TRANSNUCLEAR, INC.

E-18171
May 19, 2000

Subject: Model No. TN-68 Transport Package (Docket No. 71-9293, TAC No. L22899)

Attachment to E-18171 dated May 19, 2000
Docket 71-9293, Tac No. L22899
Responses to NRC questions dated March 29, 2000

FIGURE 1-1
GENERAL ARRANGEMENT
TN-68 PACKAGING

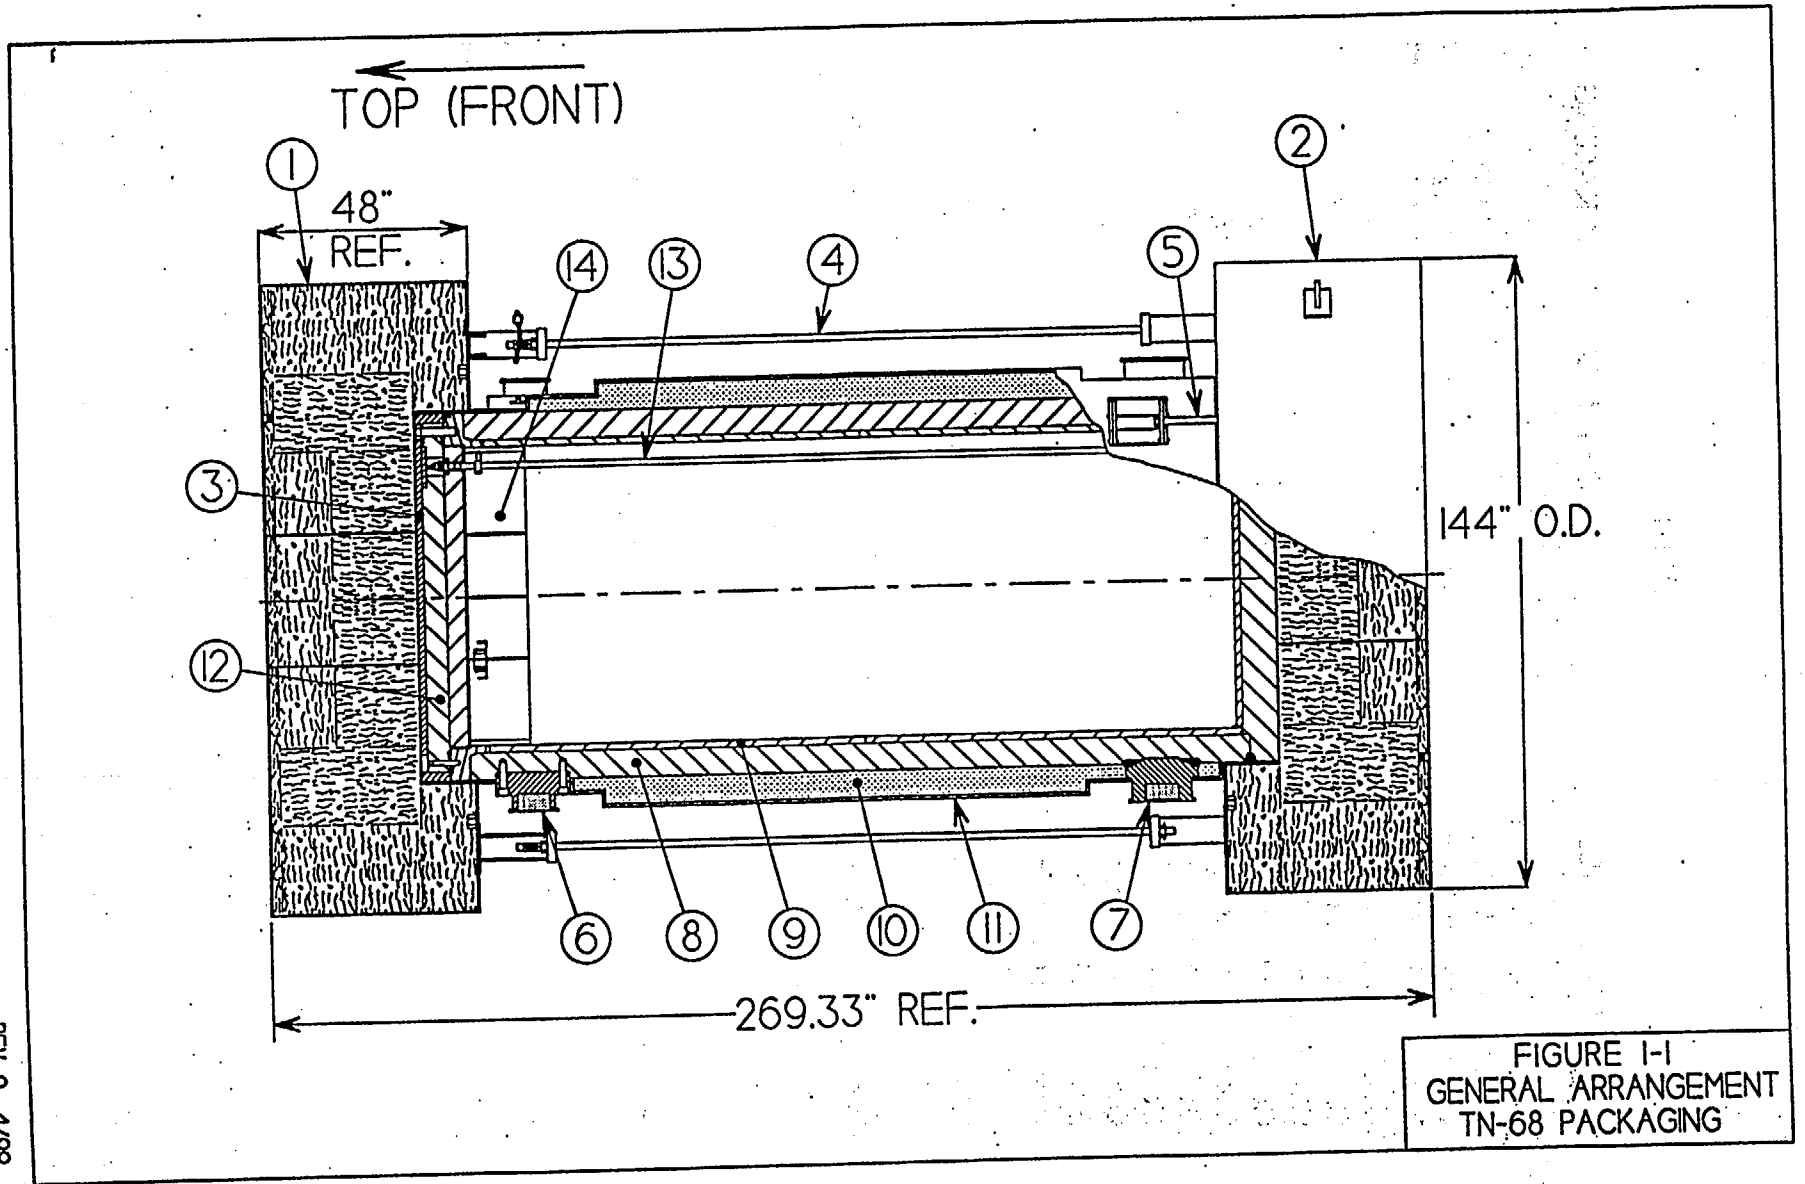
3. The response to RAI 3-1-4 is in error. TN limits consideration of accessible surfaces to the impact limiters. In addition to the impact limiters, the cask body exterior surfaces need to be considered.

The response to RAI 3-1-4 addressed the impact limiters as the accessible surface because the use of a personnel barrier protects the cask body. However, the wording talked about railings limiting access and was somewhat confusing. The revised SAR pages/drawings show a wire mesh placed around the cask body that serves as a personnel barrier. This allows only the impact limiter surfaces to be accessible.

- Added description of thermal shield used to minimize heat transfer to the bottom limiter. Increased overall length of packaging due to addition of thermal shield.
- Added description of personnel barrier. Removed reference to tarp.

FIGURE 3-5

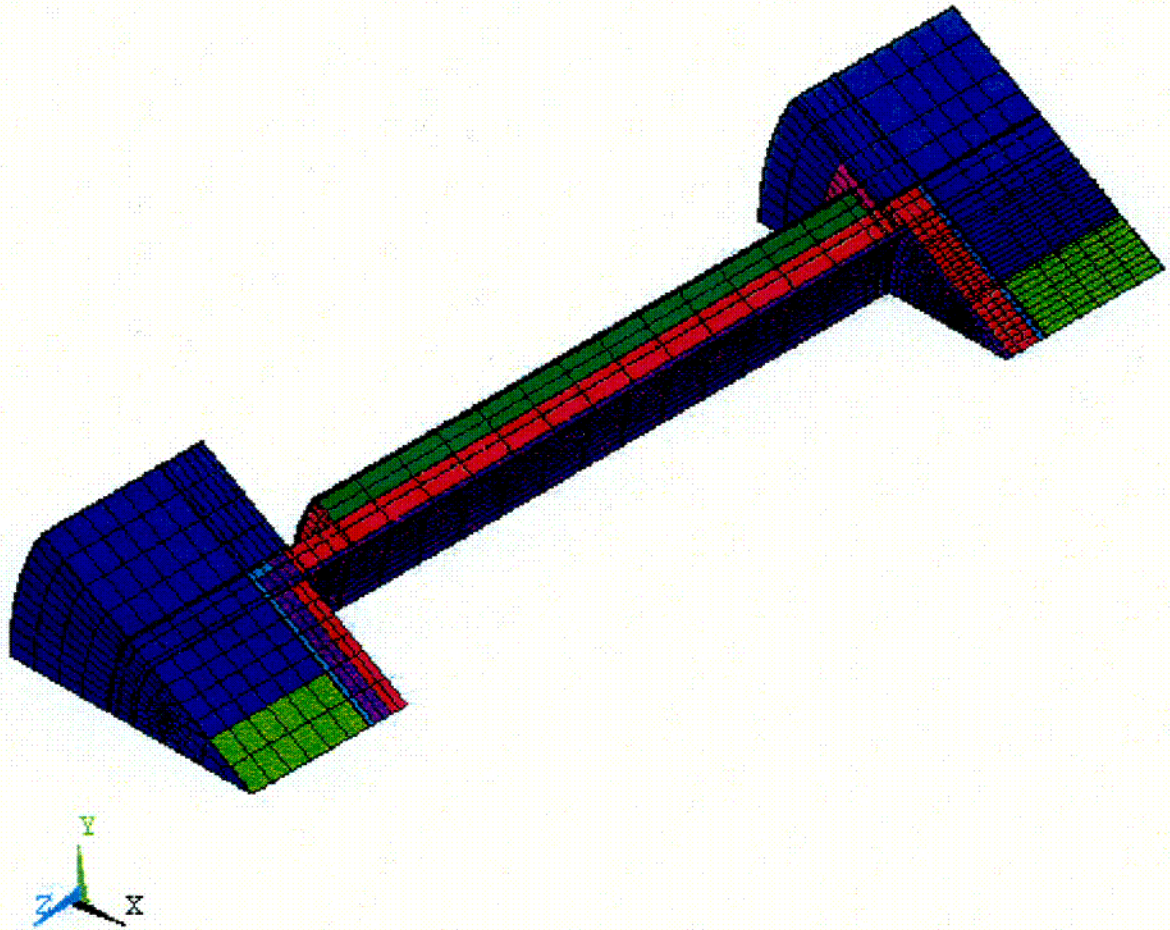
4. The response to RAI 3-6 did not address thermal degradation issues of the wood or glue. The document cited in the RAI response, NUREG/CR-0322, page 12, specifically states that the “mechanical properties of wood decrease when heated” and that “prolonged exposure to high temperature causes an irreversible decrease in properties”.

To reduce the temperature of the TN-68 impact limiter and minimize the effect of thermal degradation on the wood, a thermal shield has been installed between the bottom portion of the cask body and the rear impact limiter. The maximum wood temperature during normal transport conditions is 175 °F with the use of the thermal shield. This design change is reflected in the revised SAR pages.

- Figures 3-5, 3-9, 3-10, 3-11, 3-12, 3-13, 3-14 have been added to show the results of the additional analyses performed.
- Previous figures 3-8, 3-9 and 3-10 have been deleted.

FIGURE 3-10

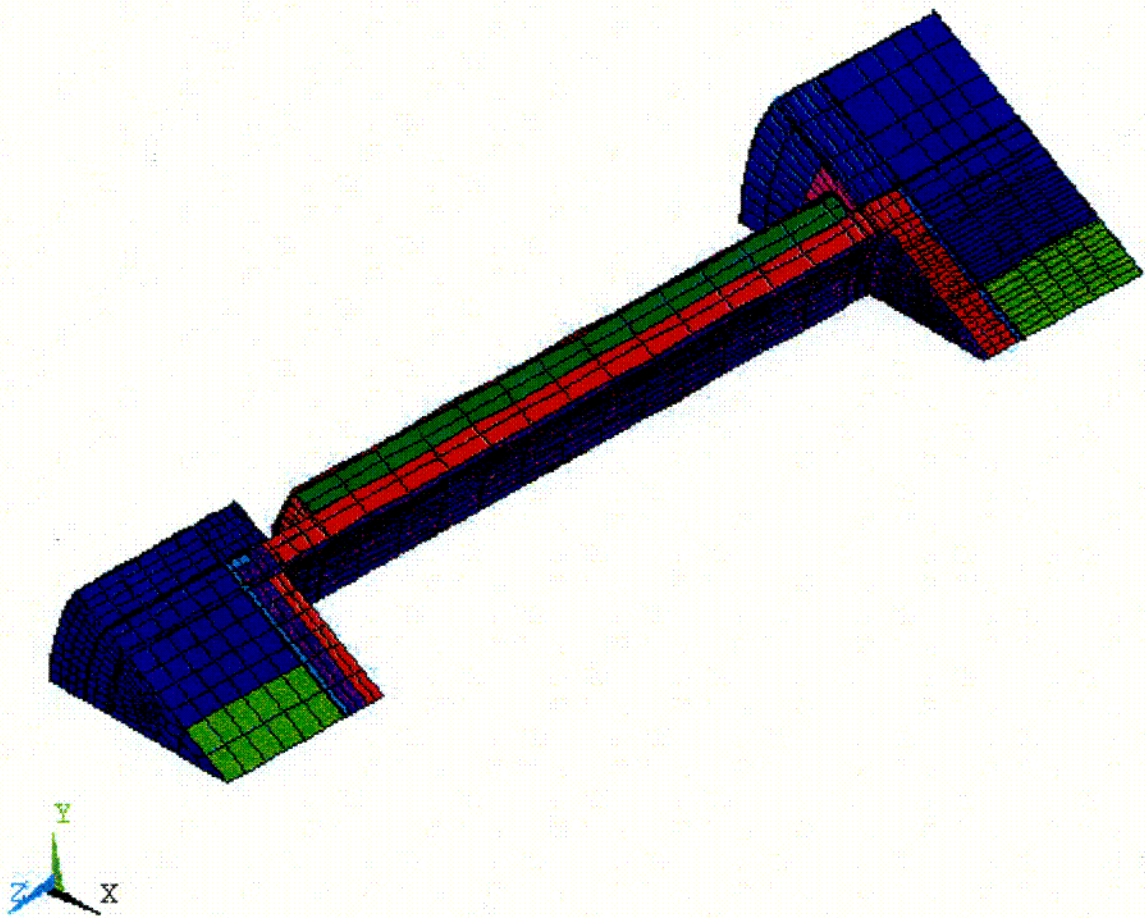
5. In response to RAI 3-9-3, the table on page 50 shows a temperature of 82 °F post fire for the radial neutron shield, which appears to be incorrect.

During a 30 foot 15° drop the front impact limiter is crushed a maximum of 19 in. radially inward resulting in the shortest distance between the fire ambient and the lid seals. This crush configuration is modeled by reducing the outer 72" radius of the front impact limiter to 53". The finite element model is shown in Figure 3-10.

FIGURE 5.3-3

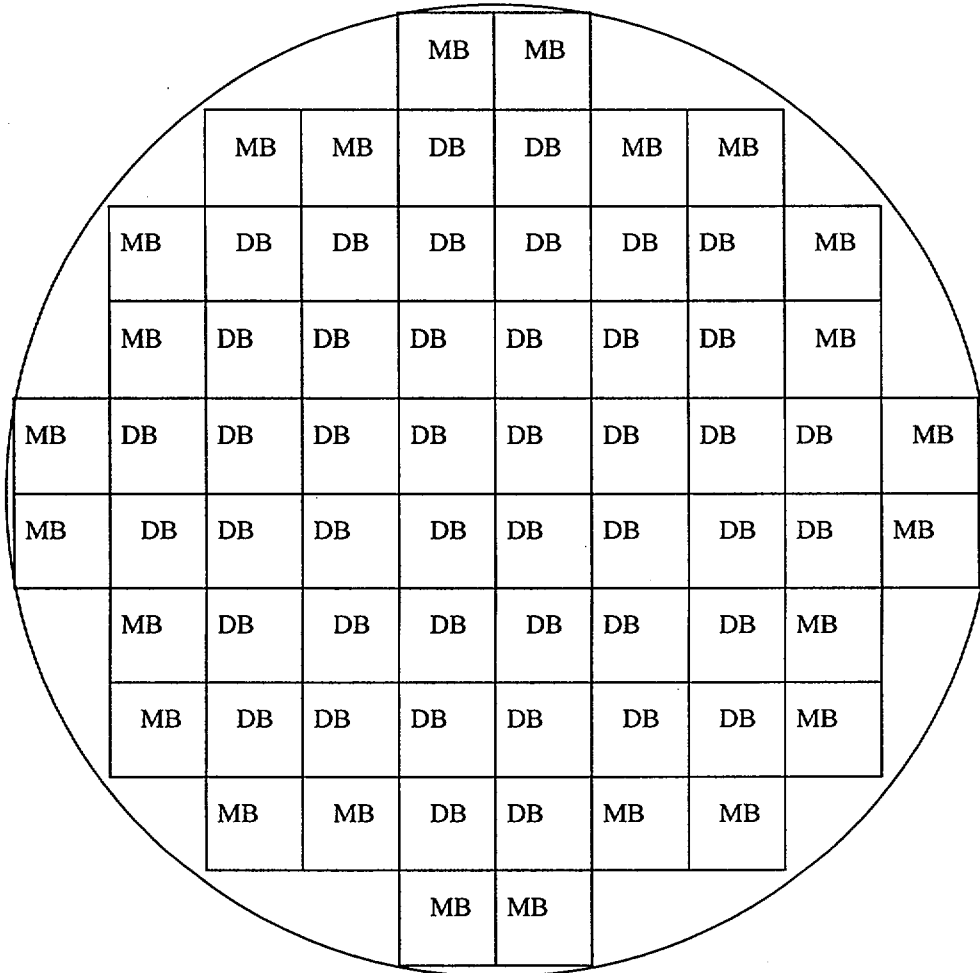
2. The response to RAI 1-6-1 discusses the concept of preferential loading. However, the details of this preferential loading are not addressed. For example, the following items need to be considered:

- 2.1 A detailed shielding analysis for the combination of 10 year cooled fuel and 26 year cooled fuel was not provided. Note that the shielding analysis presented for the package must demonstrate compliance with the shielding requirements of 10CFR71 and not depend only on future dose measurements at the time of transport.

- 2.4 The operating procedures for the package do not appear to support preferential loading.

The details of this preferential shielding analysis have been included in the revised Section 5 SAR pages being submitted. The calculated dose rates meet the requirements of 10CFR71.

- Table 5.2-8 (previous table 5.2-6) has been revised to show data for 16 year cooled fuel.
- Table 5.2-9 and 5.2-10 have been added for 10 and 26 year cooled fuel.
- Table 5.4-3 has been added.
- Figure 5.1-1 has been revised to show the increased thickness of the ancillary shield ring.
- Figure 5.3-3 has been added to show preferential loading configuration.

This section has been revised to refer to Figure 5.3-3 for preferential loading.

- 7.1.2.4 Verify the identity of the fuel assemblies loaded into the cask, and document the location of each fuel assembly on the cask loading report. Note: Type I fuel assemblies shall be loaded in the center compartments as shown in Figure 5.3-3.
